Response to Reviewers

Manuscript ID: TCCN-TP-26-1155

Hierarchical Load Balancing and Cooperative Beam Hopping for Multi-Satellite Direct-to-Cell LEO Networks

Revised manuscript Fig. 9 (reproduced). ISA sensitivity to the cooling coefficient and iterations per temperature. Curves show mean load variance for the two demand-imbalance groups; bars show mean runtime.

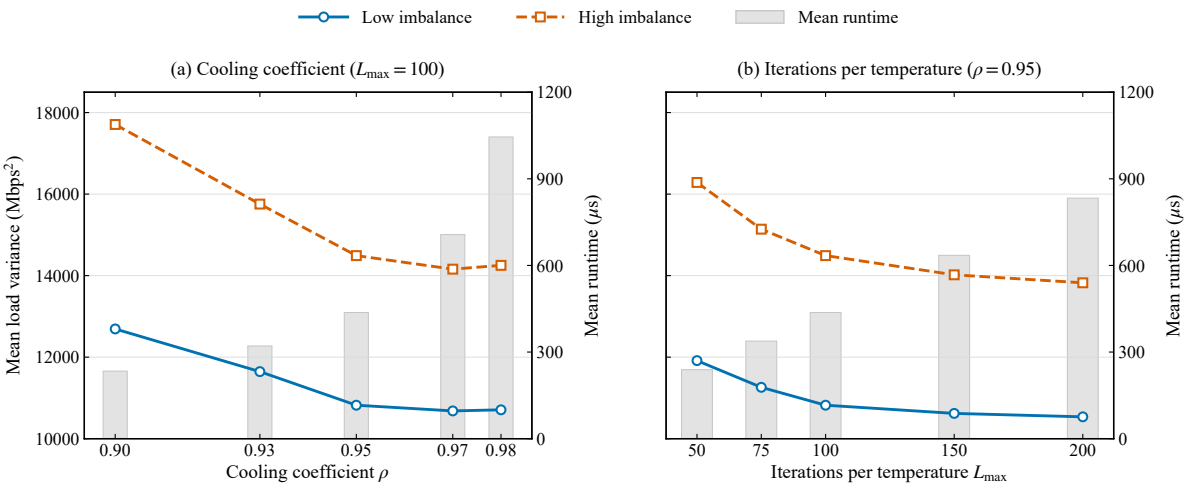
> The annealing parameters directly govern exploration depth and solution quality, yet the fixed cooling schedule may overstay at high temperatures or under-refine locally depending on the energy landscape, and parameter sensitivity across different traffic distributions remains unquantified despite its cascading impact on subsequent scheduling stages.

Thank you for this suggestion. We have added an ISA parameter sensitivity study in Section VI-B-5, with results presented in the new Fig. 9. The study examines how the cooling coefficient and the number of iterations per temperature affect load balancing and runtime under different traffic-demand distributions.

The default setting $(\rho, L_{\max}) = (0.95, 100)$ yields a mean load variance of 12656 $(\text{Mbps})^2$ and a mean runtime of 437 μs. Increasing ρ to 0.97 reduces variance by 1.86% but increases runtime by 61.78%. Increasing $L_{\max}$ to 200 reduces variance by 3.76% but increases runtime by 90.62%.

These results show that the default setting $(\rho, L_{\max}) = (0.95, 100)$ provides a good balance between load-balancing performance and runtime under the tested traffic conditions. We therefore retain this setting.

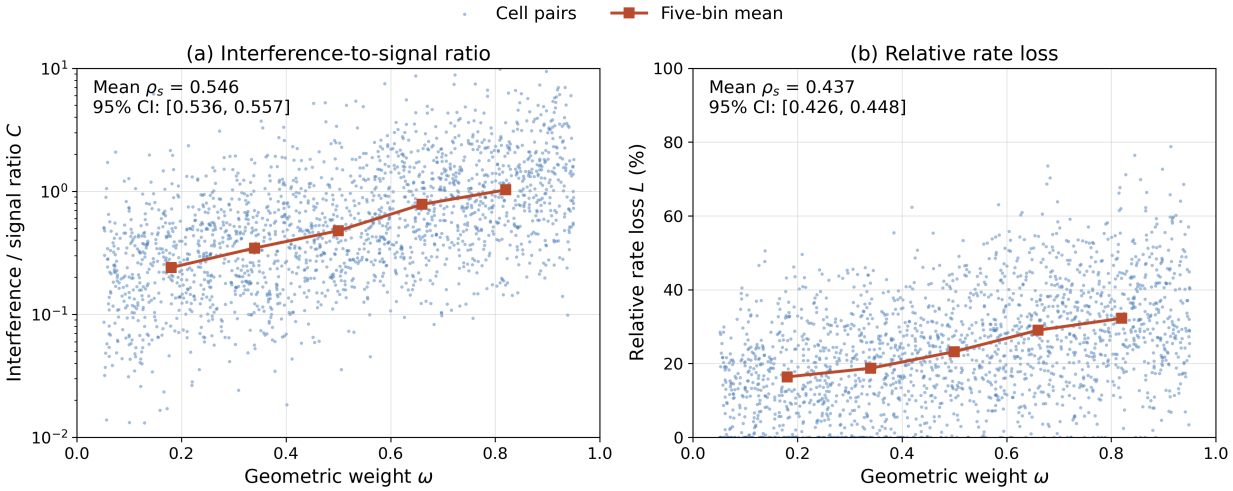
> Distance-derived interference weights in the graph attention mechanism may misrepresent actual coupling because beam sidelobe patterns and frequency overlaps determine interference beyond spatial proximity, yet this paper validates neither the correlation between static weights and achieved rate variations nor whether the learned features track physical interference dynamics under agile beam pointing.

We have added a controlled pairwise diagnostic in Section VI-B, using the antenna and channel models over 200 independent scenarios with 300 users each. The reference beam power is $P_{\text{tot}}/K_{\max}$, and the reference bandwidth is 0.5 MHz. For each direction of a cell pair, victim-cell rates are calculated with and without the specified interfering-beam contribution, keeping the desired signal, channel realization, and noise fixed. The interference-to-signal ratio and relative rate loss are then averaged over the two directions.

The mean scenario-wise Spearman correlations with the distance weight are 0.546 (95% scenario-level bootstrap CI: [0.536, 0.557]) for the interference-to-signal ratio and 0.437 (95% CI: [0.426, 0.448]) for relative rate loss. We have added Fig. R1-4 to this response to present the diagnostic results.

Overall, the physical diagnostic supports the relevance of the distance prior to physical interference effects, and the ablation supports the scheduling benefit of the coverage priors. These results support the usefulness of the proposed geometric and coverage priors for scheduling under the tested conditions.

Revised manuscript Fig. 2 (reproduced). Updated MAPPO framework, including coverage-prior attention, Gaussian samples before Softmax, and sampled-action information stored for PPO.

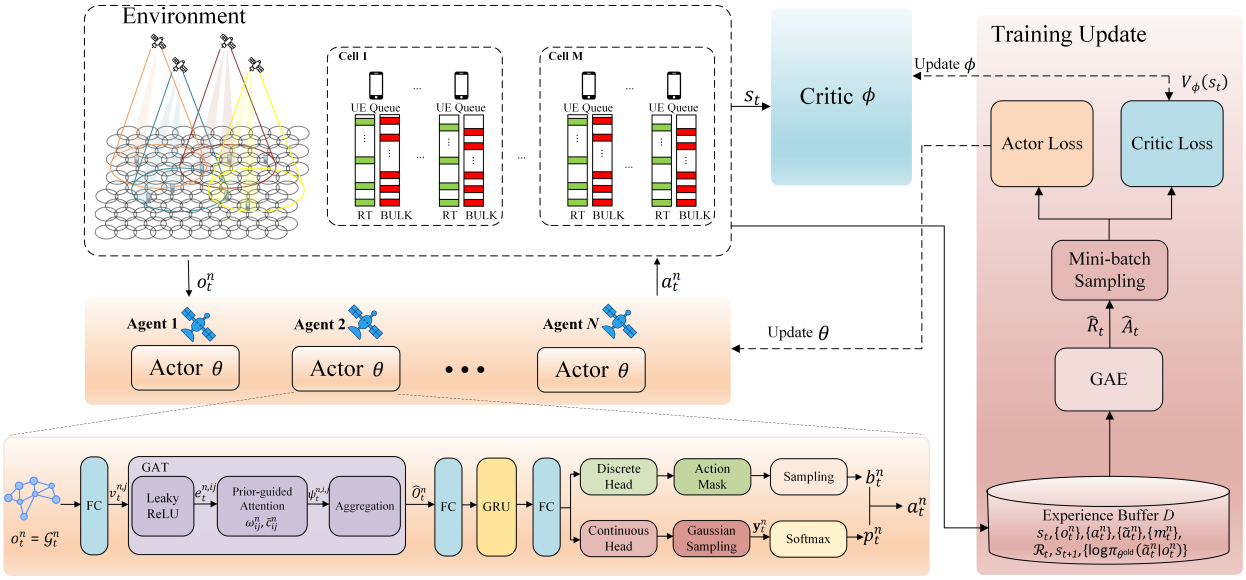
> The hybrid-action probability model is insufficiently explained. The Gaussian-to-Softmax power transformation and sequential beam selection require a clear definition of the action log-probability used in PPO.

Thank you for pointing out that the hybrid-action probability calculation was insufficiently explained. We have clarified the sampled action, the executed action, and the log-probability used by PPO in Section V-B, with corresponding updates to Algorithm 2 and Fig. 2.

The sampled action is $\widetilde{a}_t^n = (\mathbf{j}_t^n, \mathbf{y}_t^n)$, where $\mathbf{j}_t^n$ is the ordered cell-selection sequence and $\mathbf{y}_t^n$ contains the Gaussian samples for the selected cells. These samples are mapped to the executed action $a_t^n = (b_t^n, p_t^n)$ through cell selection and Softmax normalization. The sampled-action log-probability has two terms. The discrete term sums the conditional log-probabilities of the sequential selections, with each distribution normalized over the associated cells that have not yet been selected. The continuous term sums the Gaussian log-densities evaluated at the stored samples before Softmax.

For each PPO update, the current and old policies evaluate the same stored selection sequence and Gaussian samples to form the likelihood ratio. Reevaluation uses the same stepwise masks and recurrent observation context, without resampling. Algorithm 2 specifies storage of the selection sequences, Gaussian samples,

During training, actions are sampled as described above. During testing, masked Top-K selects the cells, and Softmax applied to their Gaussian means gives deterministic power allocation ratios. These descriptions specify how actions are sampled, evaluated by PPO, and executed.

Revised manuscript Fig. 8 (reproduced). Ablation results for coverage priors, GAT, GRU, and learned power allocation. Error bars show pointwise 95% confidence intervals across five independent training-seed means.

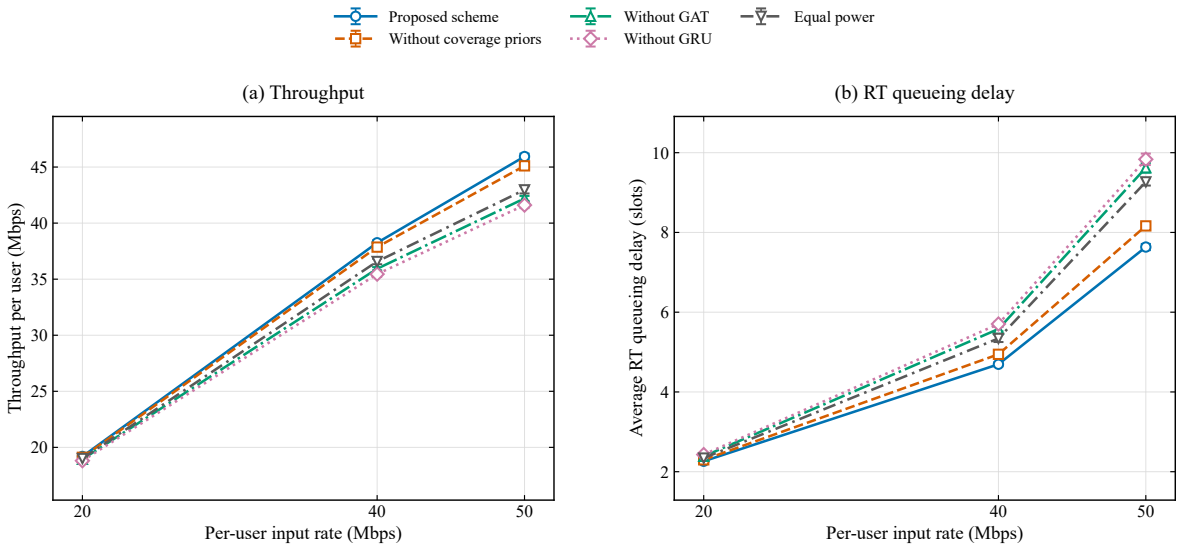
> The simulation study should better isolate the source of performance gains. Additional ablations, such as MAPPO with equal power, without GAT, and without GRU, as well as confidence intervals over multiple random seeds, should be provided.

Thank you for this suggestion. We have added an ablation study in Section VI-B-3, with results presented in the new Fig. 8. The study compares the proposed method with four variants: Without coverage priors, Without GAT, Without GRU, and Equal power. In the variant without coverage priors, the actor's coverage-degree feature is set to zero and the common-visibility attention term is removed, while the distance prior is retained. This experiment assesses the joint contribution of the two coverage priors.

All variants use the same association and testing conditions and are trained with five independent random seeds. Each trained model is evaluated on a common test-case set at per-user input rates of 20, 40, and 50 Mbps. For each training seed, performance is first averaged over the common test cases. The mean and pointwise 95% Student-t confidence interval are then calculated across the five training-seed means, reflecting variability between independent training runs.

At a per-user input rate of 50 Mbps, the full model achieves 45.94 Mbps per user (95% CI: [45.68, 46.20]) and 7.634 slots of RT queueing delay (95% CI: [7.556, 7.712]). Compared with the variant without coverage priors, throughput is 1.85% higher and RT delay is 6.49% lower. Compared with equal power, throughput is 6.92% higher and RT delay is 17.63% lower. Removing GAT or GRU causes larger degradation at this load than jointly removing the coverage priors.

Revised manuscript Fig. 7 (reproduced). Throughput per user and average RT queueing delay for different beam hopping schemes. Error bars indicate pointwise 95% confidence intervals of the means across 200 test cases.

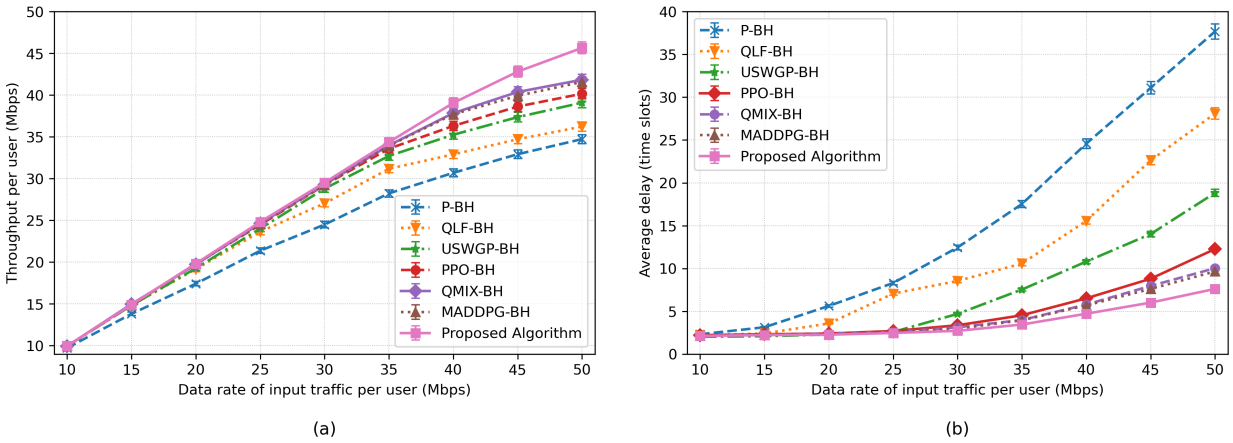
> In Figs. 6 and 7 on pages 11–12, the reported performance is averaged over 200 test instances, but the variability of the simulation results is not shown. It would be helpful to provide error bars or briefly report the standard deviation/confidence interval to further demonstrate the robustness of the performance gains.

Thank you for this suggestion. We have added error bars to the throughput and RT queueing-delay panels in Figs. 6 and 7. At each input rate, the error bars show pointwise 95% confidence intervals of the means across 200 test cases. The figure captions and Section VI-B define these intervals, and the reported $\pm$ values give their half-widths.

We have also added ablation results in Fig. 8, where the pointwise 95% confidence intervals are calculated across five independent training-seed means. The intervals in Figs. 6 and 7 describe uncertainty in the test-case means, while those in Fig. 8 characterize variability across independent training runs. These additions make the uncertainty in the reported performance explicit. Figure 7 is reproduced below as an example; the multi-seed ablation is reproduced under Comment 2.7.
